Terminal connection changes:
KSQ105 & KSQ105N with single part connectors to KSQ104F2.

MTD KSQ105 T2-C

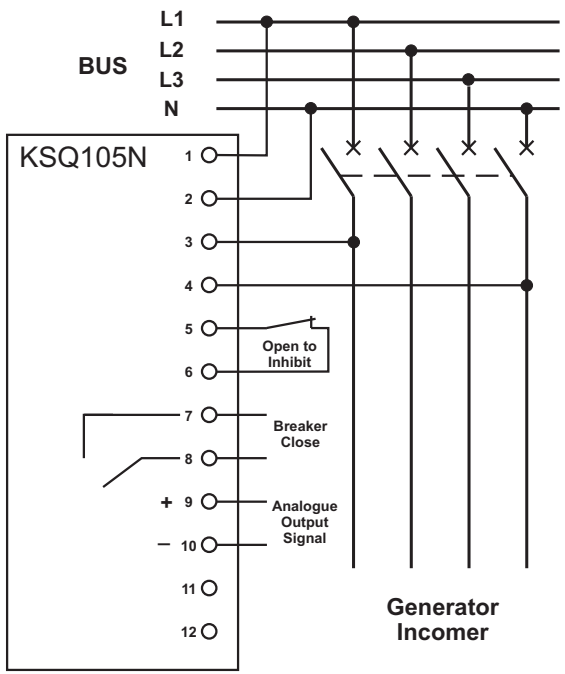
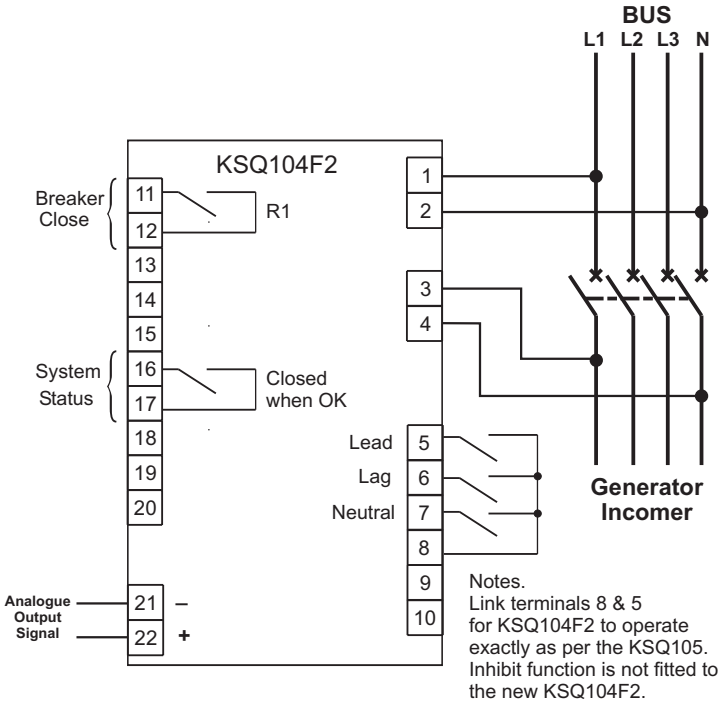
KSQ105N Terminal	KSQ104F2 Terminal
1	1
2	2
3	3
4	4
5	N/A
6	N/A
7	11
8	12
9	22
10	21
11	
12

Notes.
Link terminals 8 & 5 for KSQ104F2 to operate exactly as per the KSQ105. Inhibit function is not fitted to the new KSQ104F2.
